City of Huntington Beach Planning and Building Department
STAFF REPORT

SUBJECT: MITIGATED NEGATIVE DECLARATION NO. 11-007/COASTAL DEVELOPMENT PERMIT NO. 11-012/CONDITIONAL USE PERMIT NO. 11-021/ENTITLEMENT PLAN AMENDMENT NO. 11-007/VARIANCE NO. 11-005 (PIERSIDE PAVILION EXPANSION)

LOCATION: 300 Pacific Coast Highway, 92648 (northeast corner of Pacific Coast Highway and Main Street)

**SITE PLAN/
LANDSCAPE**

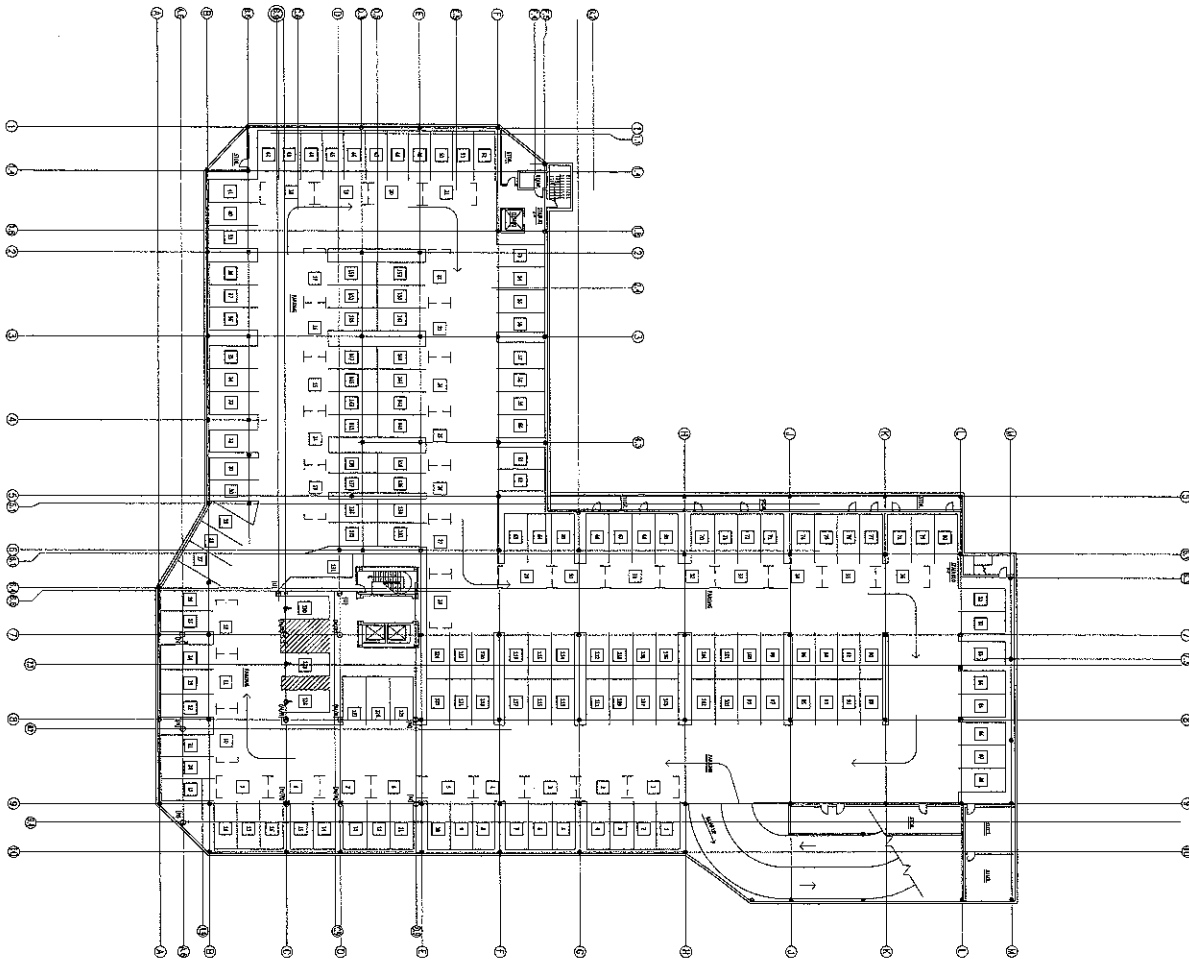
Sheet A-0 ("Site Plan / Landscape") depicts the new footprint of the proposed expansion. Present on this sheet are two vertical dashed lines appearing to correspond to the Third Street vacation with the notation "60'0" View Corridor" in the very smallest of fonts which is only readable in the native PDF copy of the plans (this is the exact reason I ask for native PDFs). This sheet depicts major encroachment of the expansion into the view corridor by as much as approximately 16-17ft in places.

FIRST FLOOR PLAN

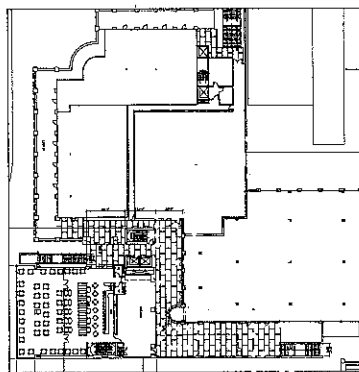
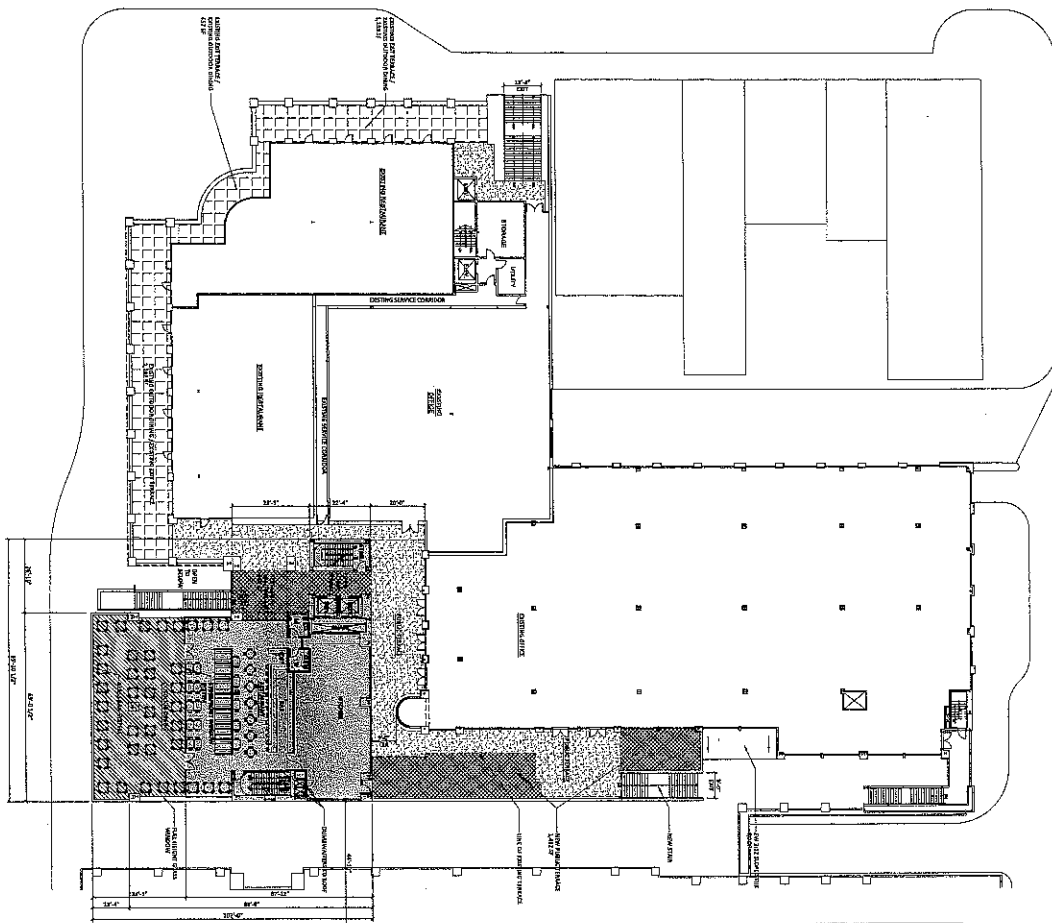
- Require that the reference to new office area on the 1st floor plan be removed. Only visitor-serving commercial uses are allowed anywhere on the ground floor. (Condition of Approval No. 1.h) – See discussion under Downtown Specific Plan below.

Section 3.3.1.3 Permitted Uses of the DTSP requires that visitor-serving commercial uses are required for all ground floor square footage in the District 1 Visitor Serving Commercial Overlay. The submitted plans indicate that new office is proposed on the ground floor. Staff is recommending a condition of approval that would require any reference to new office area on the 1st floor to be removed from the plans. While the use complies with the base zoning district and all applicable land use plans, the project includes a request for a variance to exceed the maximum height of 45 feet. The project proposes four stories with a building height of 68 feet topped with an 8-foot glass screen wall and an architectural tower (mechanical housing) up to 90 feet high. The proposed project would not, therefore, comply with the height requirement of the Specific Plan. However, the design intent is to match the existing building height (which was permitted pursuant to the regulations of the 1988 DTSP) and floor plates to allow for more efficient access and internal circulation. However, the existing 4th floor top plate exceeds the minimum required floor height and as such, staff recommends a condition of approval to decrease the building height from top of parapet of 68 feet to 62 feet. This would allow for the proposed design intent to match floor plates and at the same time, limit the extent of the variance request to exceed the maximum height. The proposal to deviate from the maximum height, as conditioned, will not result in the development being disproportionate to the building height of surrounding developments due to the existing height of

- Require that the reference to new office area on the 1st floor plan be removed. Only visitor-serving commercial uses are allowed anywhere on the ground floor.
